UNITED STATES PATENT AND TRADEMARK OFFICE

Office Action Summary	Application No. 10/598,211	Applicant(s) ZINONI ET AL.	
	Examiner CHRISTOPHER B. MCKINLEY	Art Unit 3781

DETAILED ACTION

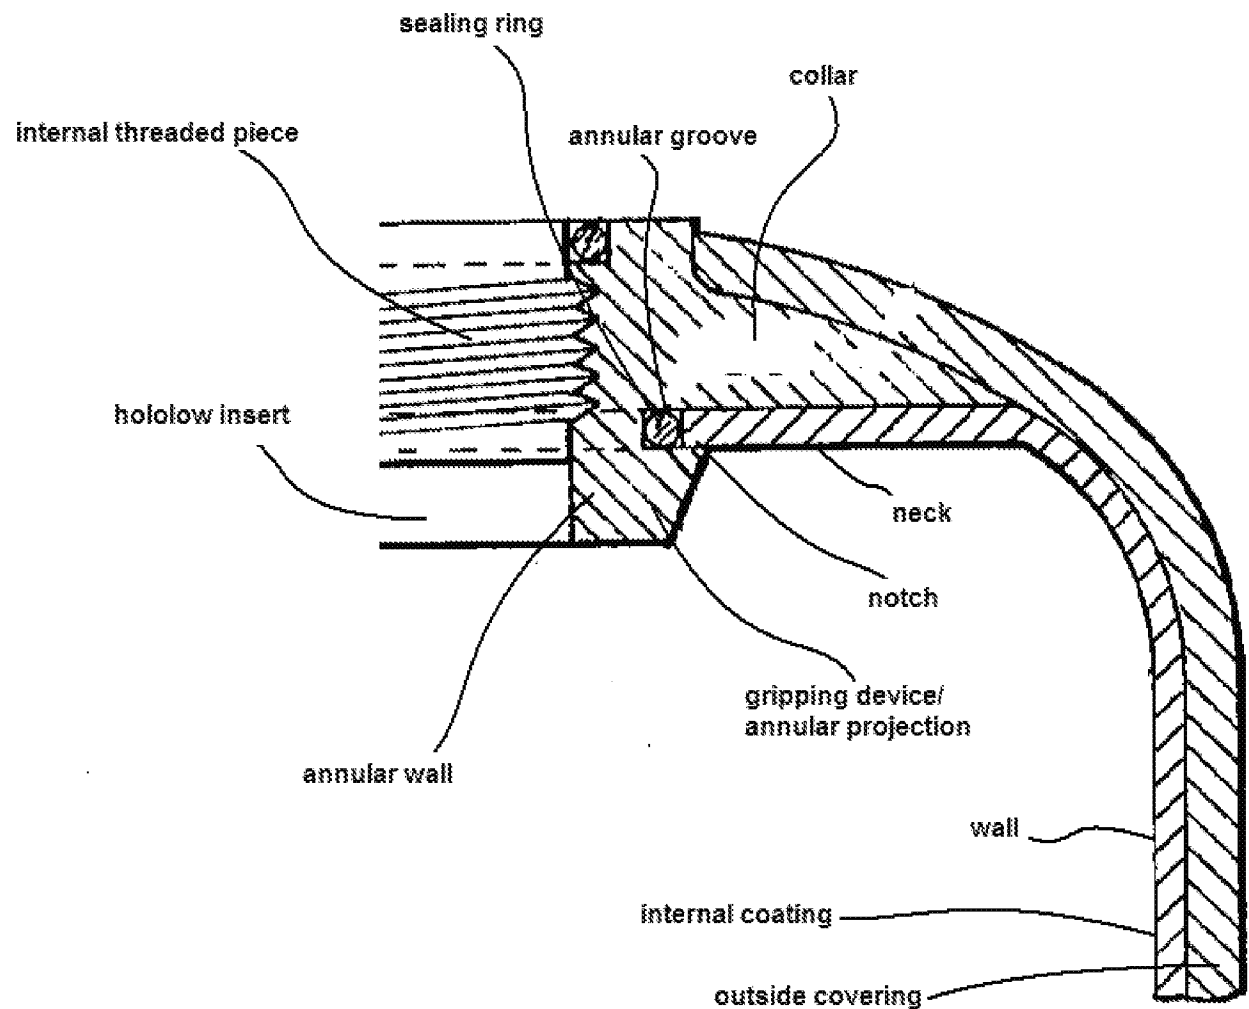
2. Claims 23, 27 and 29-39 are rejected under 35 U.S.C. 102(b) as being anticipated by Harmon (3,907,149). Harmon discloses the limitations of the claims including a tank (figs. 1-8) comprising the limitations depicted below:

Wherein the insert is made of an insert material having a hardness greater than the internal coating, the internal coating is polyethylene, the covering is fiberglass and the fiberglass contains a matrix of resin (col. 4, lines 18-53), structure suitable for holding the tank (41).

6. The references do not have an insert having a collar which projects radially beyond the annular wall of the insert, whereby a portion of the outer covering holds the collar with a neck of the coating, and wherein the insert has gripping elements suitable for making a mechanical connection with the coating, the gripping elements comprising annular projections extending radially from said annular wall. The references do not have an insert with gripping elements suitable for making notches for connection with

said coating, said gripping elements comprising annular projections extending radially from said annular wall. Also, the references do not have a positive interlocking as recited in claim 26.

7. Examiner disagrees. All of the abovementioned limitations are depicted by Harmon in the image above, see par. 3. Regarding claim 26, Newhouse teaches the interlocking fit as claimed, see par. 5 above. Moreover, 37 CFR 1.111(b) states, "A general allegation that the claims define a patentable invention without specifically pointing out how the language of the claims patentably distinguishes them from the references does not comply with the requirements of this section." Applicant has failed to specifically point out how the language of the claims patentably distinguishes them from the references.
